Santa Ana Regional Water Quality Control Board

COUNTY OF ORANGE SEPTEMBER 6, 2013 REQUEST FOR REVISIONS TO THE NEWPORT BAY WATERSHED SEDIMENT TMDL MRP NO. 99-74

**Rationale for February 14, 2014 Amendments to Monitoring and Reporting
Program No. 99-74
Total Maximum Daily Load for Sediment in the Newport Bay Watershed**

Monitoring and Reporting Program No. 99-74 (as amended on February 14, 2014)

Figure 1: Newport Bay Watershed Sediment Monitoring Locations

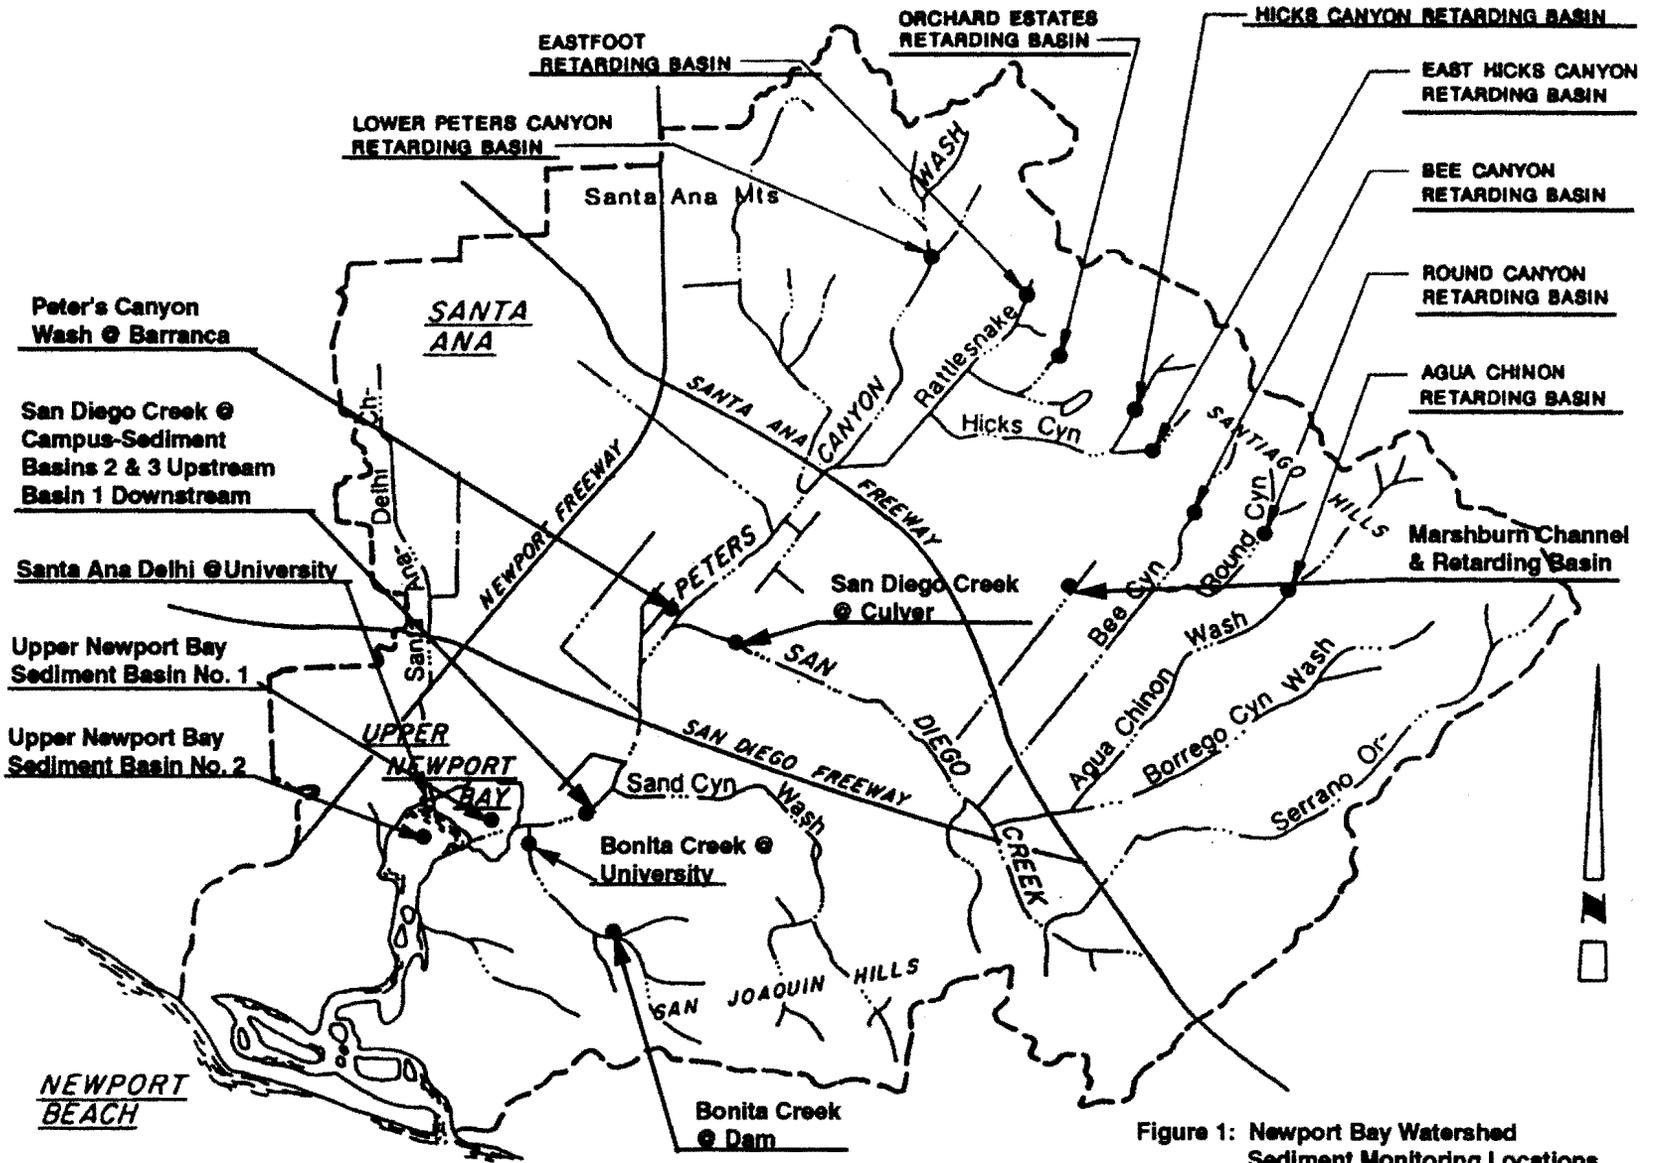
1. Pursuant to the Sediment TMDL, Requirement No.1.b for the determination of TMDL compliance, the discharger shall conduct sediment monitoring at each monitoring station specified in Table 1 at the specified frequency from July 1 to June 30 of each year. Figure 1 shows the locations of these monitoring stations.

- Pursuant to the Sediment TMDL, Requirement No. 1.b.1 for the determination of load allocation compliance, the discharger shall conduct total suspended sediment monitoring at each monitoring station specified in Table 2 at the specified frequency during the period of July 1 through June 30 of each year. Figure 1 shows the locations of these monitoring stations.
